Burbage Parish Council- Written Representation

Transport

Environmental Statement Chapter 8: Transport and Traffic (APP-117)

Figure 5-8: AM 2036 WoDevWInf-WoDev

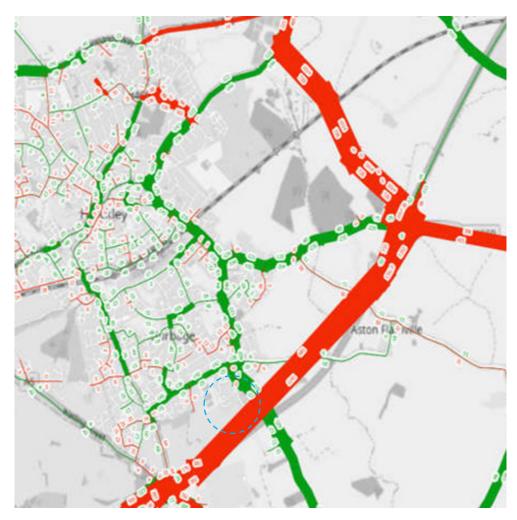
In trying to understand the impact of the introduction of the link road, paragraphs 5.92-5.96 offer the best opportunity. Unfortunately, the captions for figures 5-8 and 5-9 introduces labels of 'WoDWInf-WoDev' of which the reader is again left to deduce the meaning.

It is believed, these figures show the modelling the AM & PM peak hour changes with the thickness of the Red lines show the level of increase and the thickness of the Green lines showing the level of reduction, when compared with the current road layout. Within the broad conclusion that traffic with Burbage is reduced, there appears to be pockets of increase within the middle of the village; are these anomalies of the modelling?

To illustrate this point on the next figure, a single link has been highlighted with a blue dashed circle. We believe this street is Bullfurlong Lane, a residential cul-de-sac (of forty properties), which continues via an un-made track to a single farm. This is one of a number of roads on these diagrams, in which following the introduction of development shows increased traffic. It is difficult to understand how any material impact could be modelled for this street.
